MIL ON With DTC P0A1B94

YEAR(S)	MODEL(S)	ADDITIONAL INFORMATION
2025 - 2026	Camry HV

Some 2025 — 2026 model year Camry HV vehicles may exhibit a MIL on condition with DTC P0A1B94 (Drive Motor "A" Control Module Unexpected Operation) stored. The logic in the MG ECU has been modified to address this condition.

Figure 1. Location of the Cooling Fan Plug

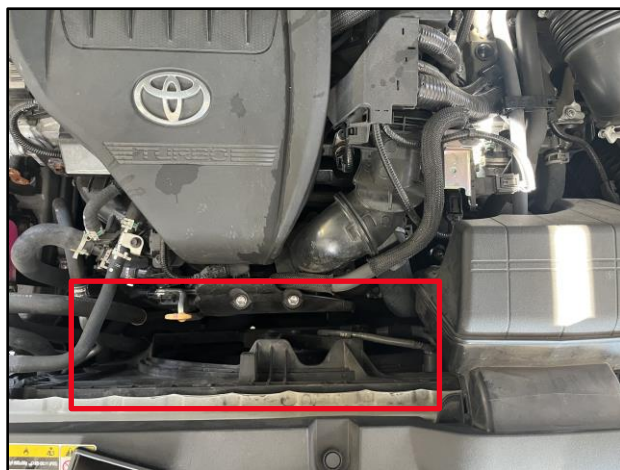
1. Confirm the DTC P0A1B94 was set in DTC history.
2. Use GTS+ to confirm if the MG ECU has the previous calibration ID.
Does the MG ECU have the latest calibration ID?
 - **YES** — This bulletin does not apply. Continue diagnosis using the applicable Repair Manual.
 - **NO** — Continue to step 3.
3. Unplug the engine cooling fan.
